T.I.P Project No. I-3819B
Proposed I-40/I-77 Interchange Area Improvements
Iredell County
WBS Element 34192.1.2

DA No. SAW-2018-01504

The Corps has completed the evaluation of your request and has determined that it is appropriate and reasonable, and no public notice is required for this modification. Therefore, the permit is modified as requested, including requested exemptions from pipe burial and revised mitigation (revised Mitigation Responsibility Transfer form is enclosed), and as shown on the revised PERMIT DRAWINGS, Sheets 1 through 67 (I-3819B/U-6039), Rev. 11/02/2020, and UTILITY PERMIT DRAWINGS, Sheets 1 through 8 (I-3819B/U-6039), Rev. 11/02/2020.

Subject: Modification to the 401 Water Quality Certification Pursuant to Section 401 of the Federal Clean Water Act with ADDITIONAL CONDITIONS for Proposed improvements to the I-77 and I-40 interchange in Iredell County, including Broad Street improvements, TIP I-3819B, U-6039, WBS 34192.3.2. NCDWR Project No. 20191006 v.2

PERMIT DRAWING
SHEET 31 OF 67
Rev. 11/02/2020

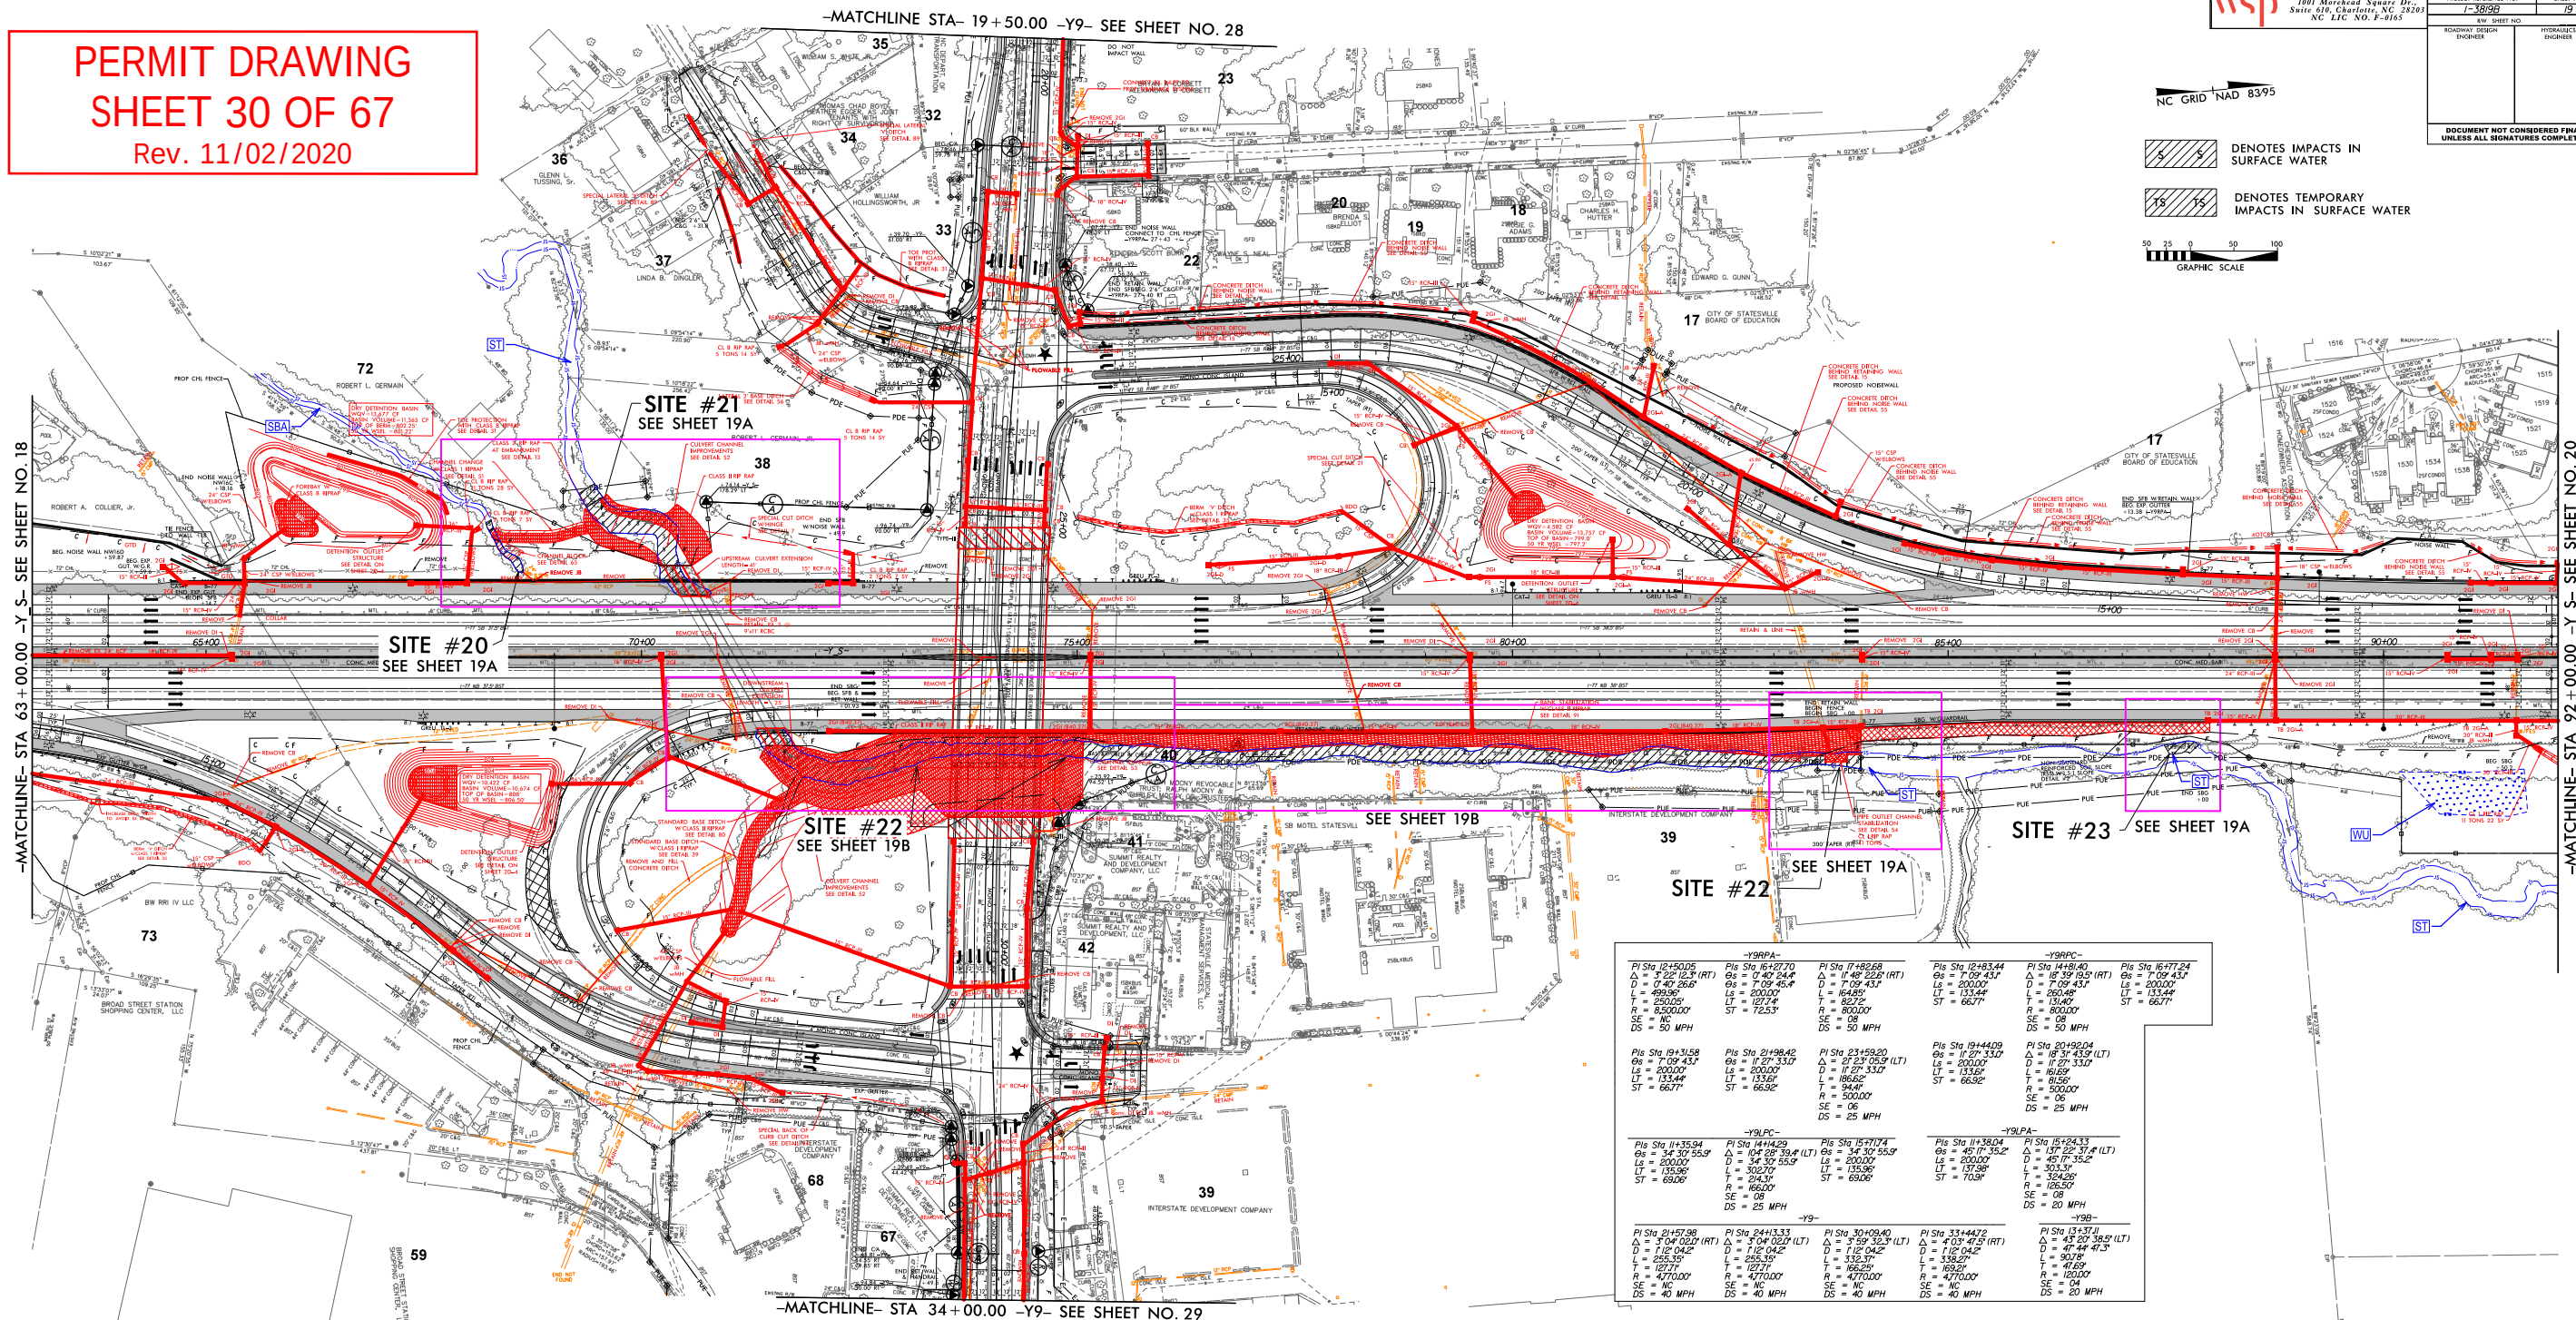
NOTE: PER COMMENTS RECEIVED FROM NCDOT ON 10/16/20, JS LINES HAVE BEEN MODIFIED ALONG SITES 21, 22, AND 23 TO FOLLOW THE SURVEYED TOPOGRAPHY. NO RIPRAP WILL BE PLACED IN THE STREAM BED ALONG AREAS OF BANK STABILIZATION.
